Project Name: Opal Grand Hotel

Request: Class I Site Plan Modification

SITE PLAN REVIEW AND APPEARANCE BOARD STAFF REPORT

Consideration of a Class I Site Plan Modification associated with minor elevation changes to the west elevation for the Opal Grand Hotel (fka Marriott) located at 10 North Ocean Boulevard.

1
A3.01 SCALE : 1/8"-1'-0"

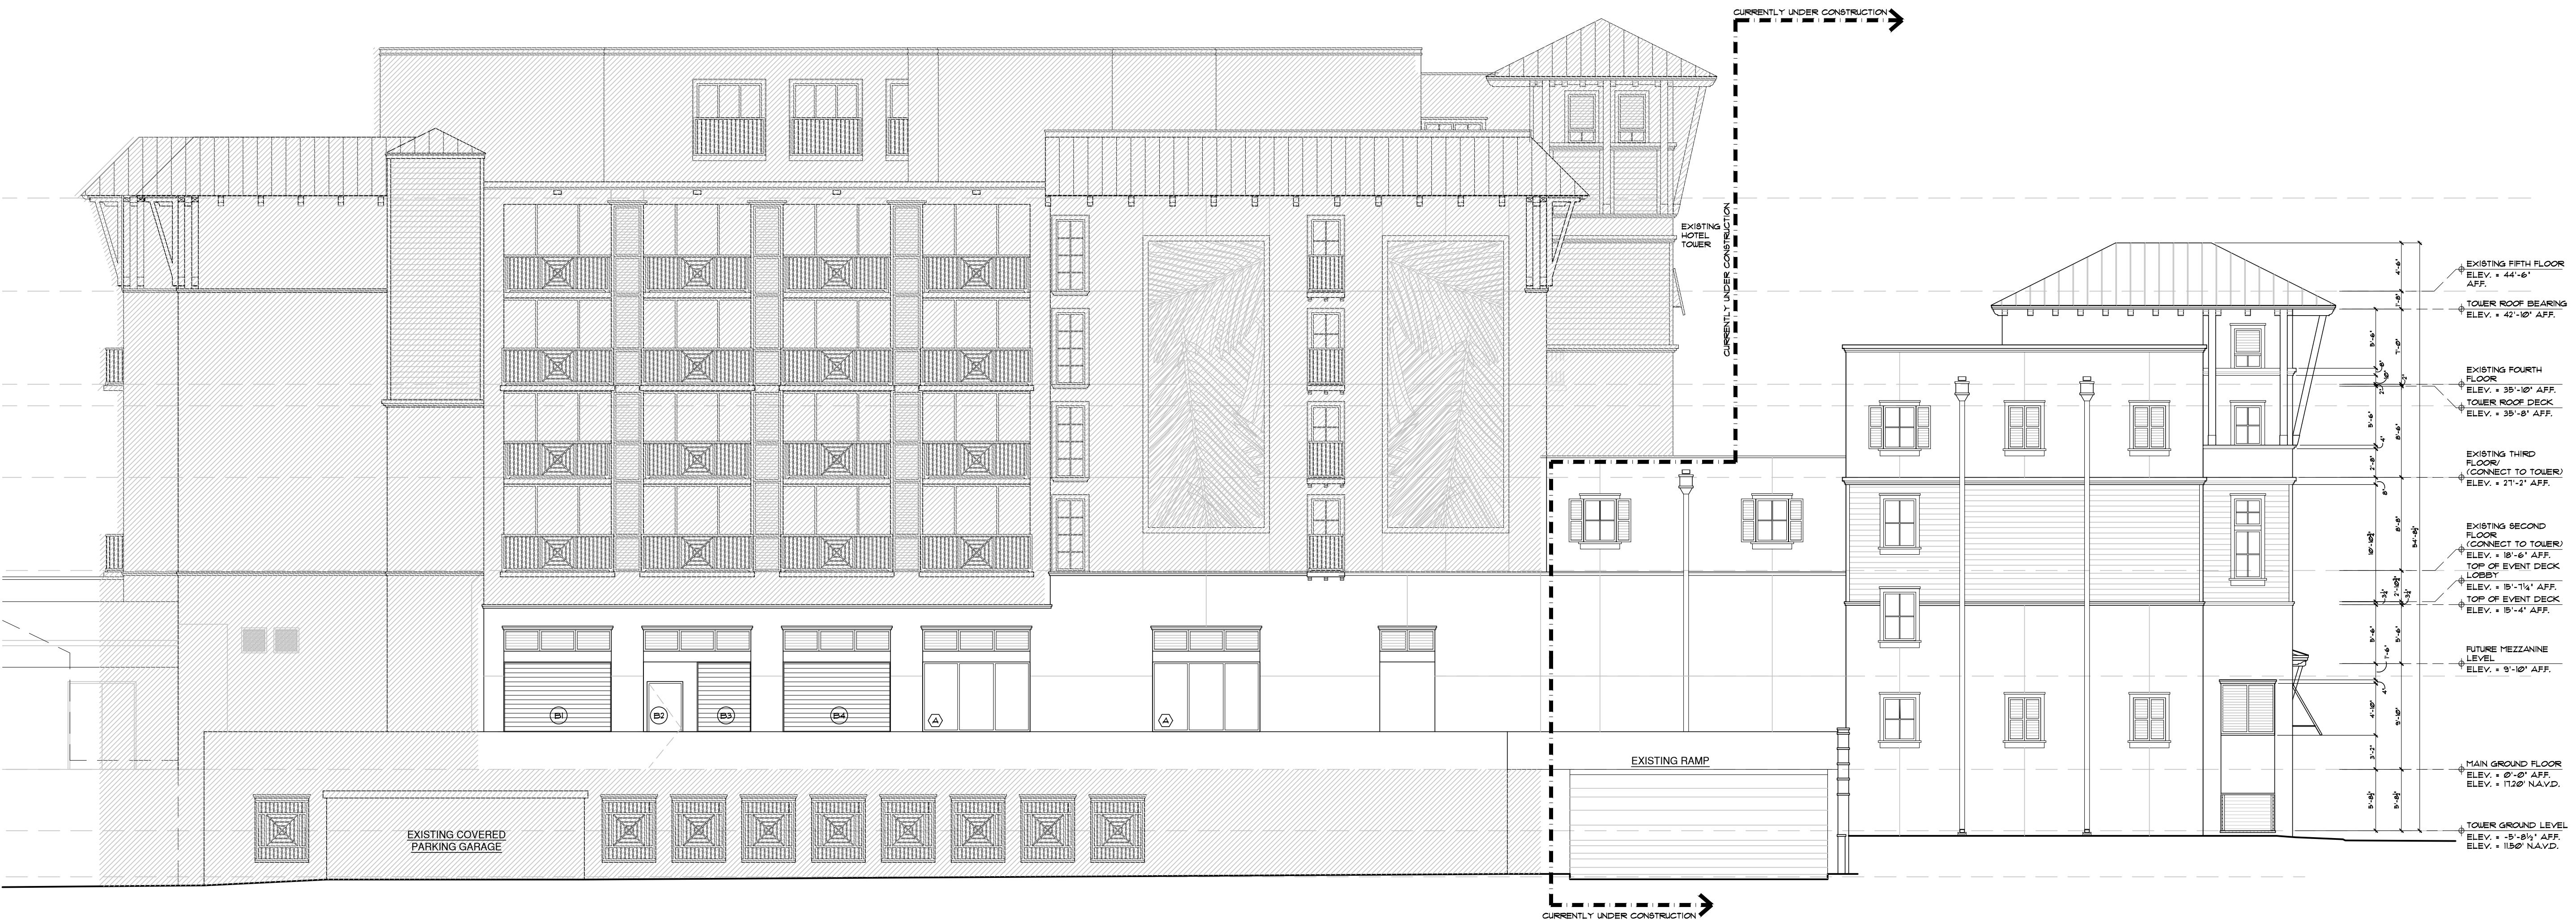
Architectural Elevations:

As noted, the Opal Grand Hotel transitioned from a Mediterranean Revival architecture style to Anglo-Caribbean architecture as part of the Class II Site Plan Modification in June of 2019. A common element of this architecture is multiple building volumes of varying heights, widths, and functions assembled to form a single structure. The sloped roofs also display a defining characteristic of Anglo-Caribbean architecture along with balconies with the exterior finish in smooth stucco.

The proposed modifications are consistent with the building's style and will continue the existing harmony with the surrounding area. The interior modifications will not affect the evolving environment or depreciate in appearance and value. The exterior improvements provide an enclosed service area for loading, and trash pickup, which will be closed off with rolling doors providing a buffer for potential guest or visitors walking by. The exterior finishes will match the existing hotel, thereby keeping in harmony with the proposed developments in the general area and the Comprehensive Plan.
